Errata Note:

Corecell PCB #e539v01a
Reference Design

SX1302 Corecell
Errata Note

Figure 2: SX1302 Datasheet Extract

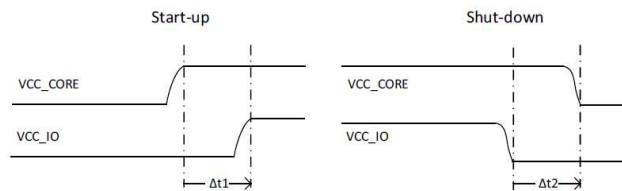
To ensure proper control of all digital IOs during the power-up and power-down sequences of the SX1302, VCC_CORE shall be enabled *before* VCC_IO at start-up, and disabled *after* VCC_IO at shut-down.

$\Delta t1$ and $\Delta t2$ must be equal to or greater than 0.

Note that the recommendation mostly concerns the start-up sequencing. At shut-down, energy storage will be quickly depleted, shutting down the complete board, so no specific measure is put in place to handle the shut-down process.
